# Sonoma County Planning Commission **STAFF REPORT**

**FILE:** DRH16-0006  
**DATE:** August 3, 2017  
**TIME:** 1:30 PM  
**STAFF:** Georgia McDaniel, Project Planner

**Appellant:** Valley of the Moon Alliance (VOTMA)  
**Applicant:** Flora Li for Tohigh Investment  
**Owner:** Tohigh Investment SF LLC (Tohigh)  
**Location:** 900, 1200, 1202, and 1204 Campagna Lane, Kenwood  
APNs: 051-260-014 Supervisorial District No.: 1  
**Subject:** Appeal of Design Review approval for a new Inn, Spa, and Restaurant  
**PROPOSAL:** Request for final Design Review approval for an inn, spa, and restaurant on a 51.9 acre parcel.

Uphold the October 19, 2016 Design Review Committee approval of the revised project design and site plan modifications with two minor changes required by the Open Space Conservation Easement.

**A**  
7  
**EASTERN PARKING - CONCEPTUAL LAYOUT**  
SCALE: 1" = 30'

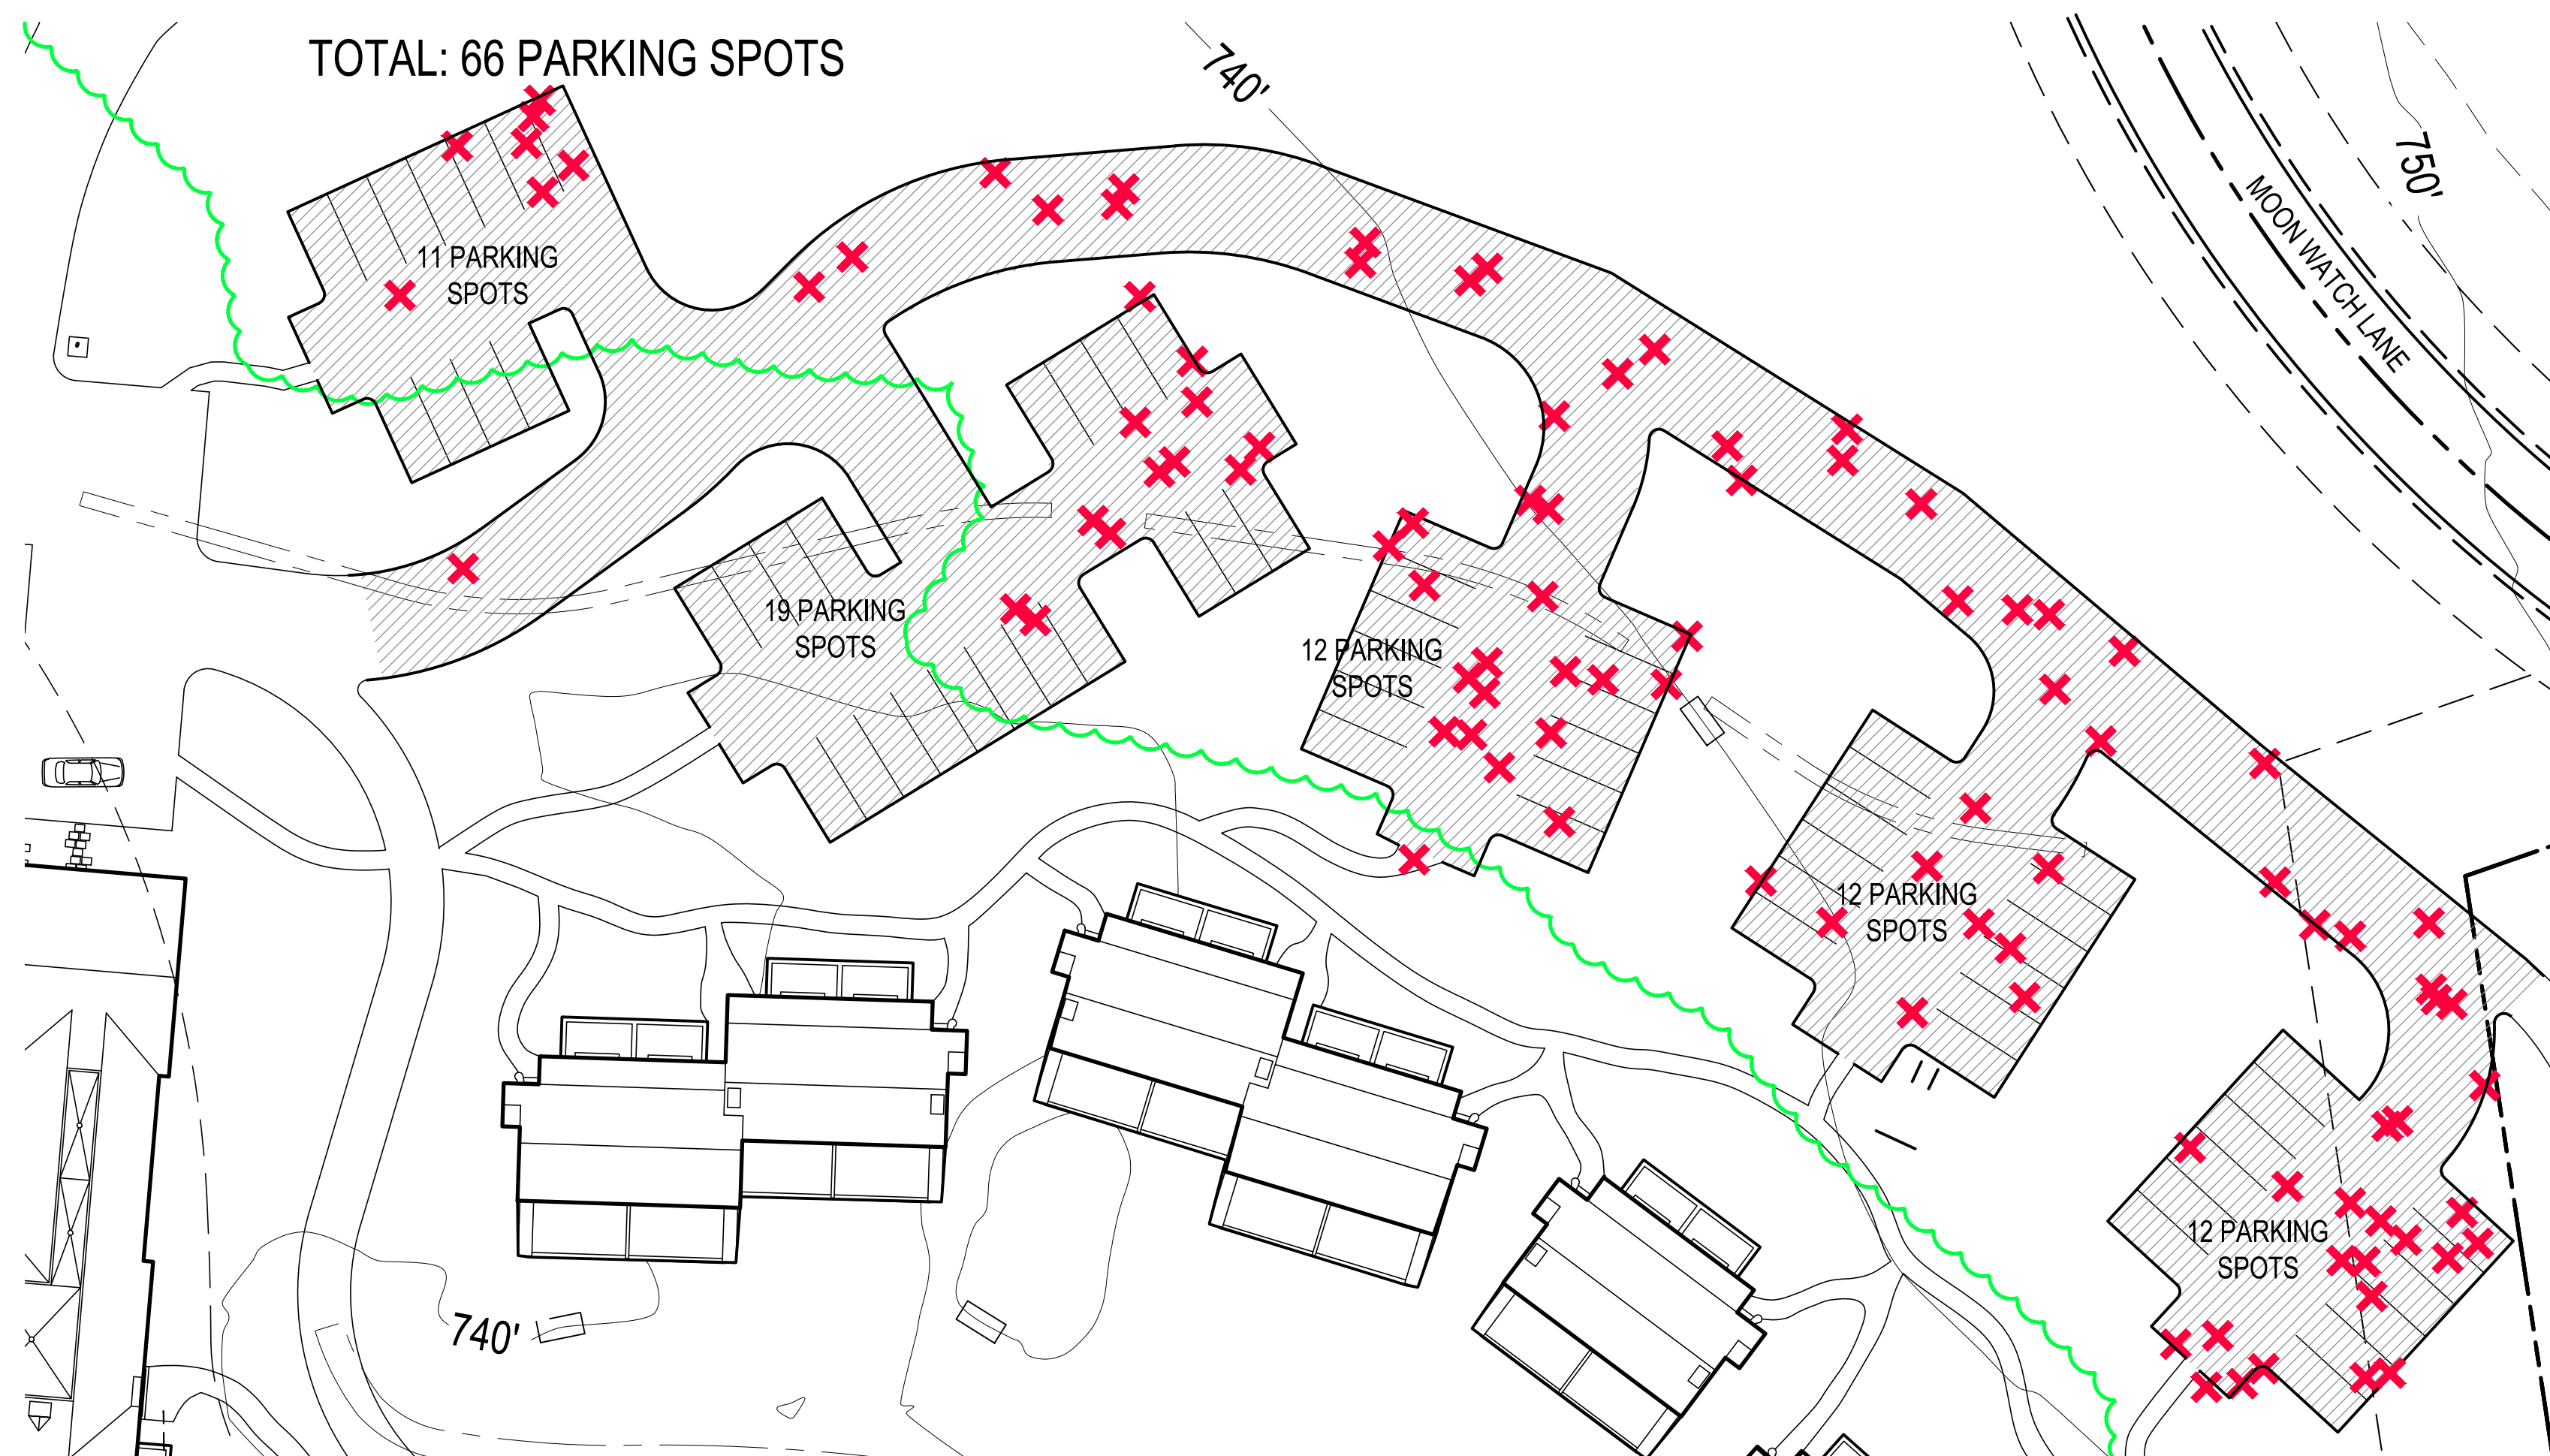
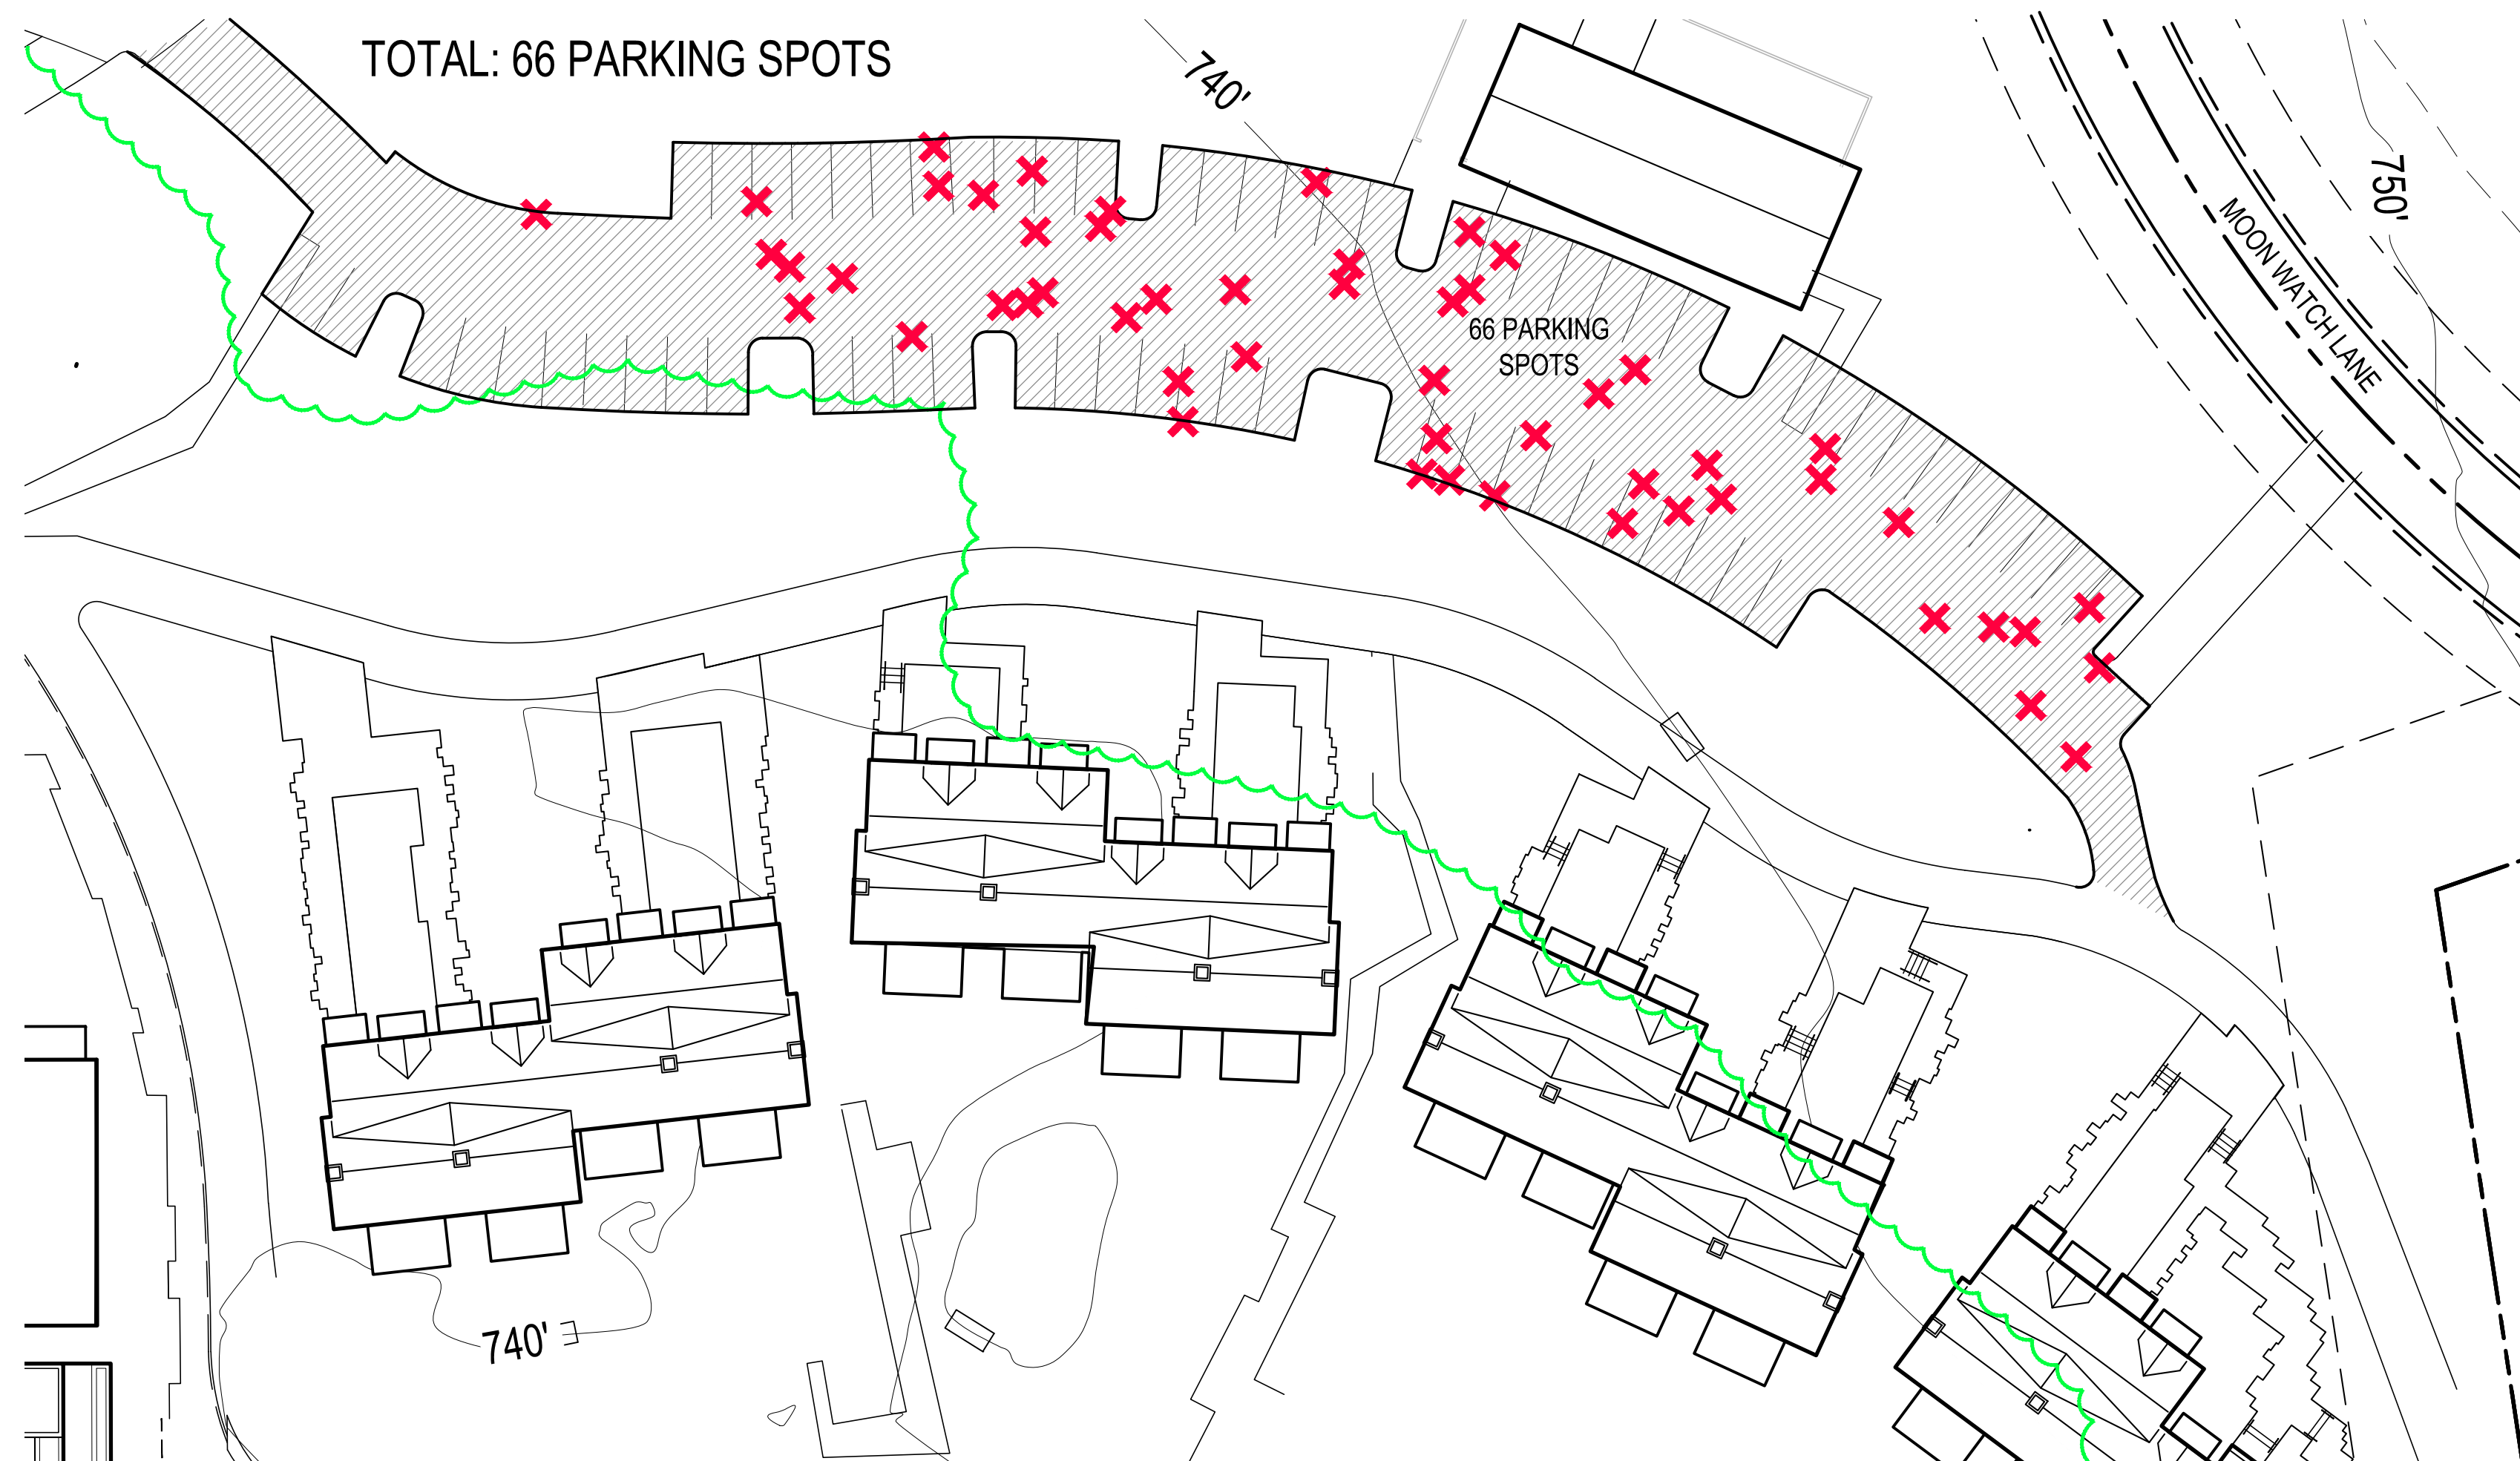
Appellant contends that aggregation of parking into two new 66- and 36 -space parking lots will create tree removal and habitat impacts and questions whether the Open Space District was consulted on the new layouts.

Changes to the western parking lot layout would require removal of 37 trees compared to 84 trees with the conceptual design. (BGK Summary of Impacts, Sheet 7.) The relocated eastern parking lot for the proposed design would remove 54 trees compared to 99 for the conceptual design. (BGK Summary of Impacts, Sheet 8.) Addition of the support building alongside the eastern parking lot would require removal of 13 trees not removed with the conceptual design. (BGK Summary of Impacts, Sheet 11.)
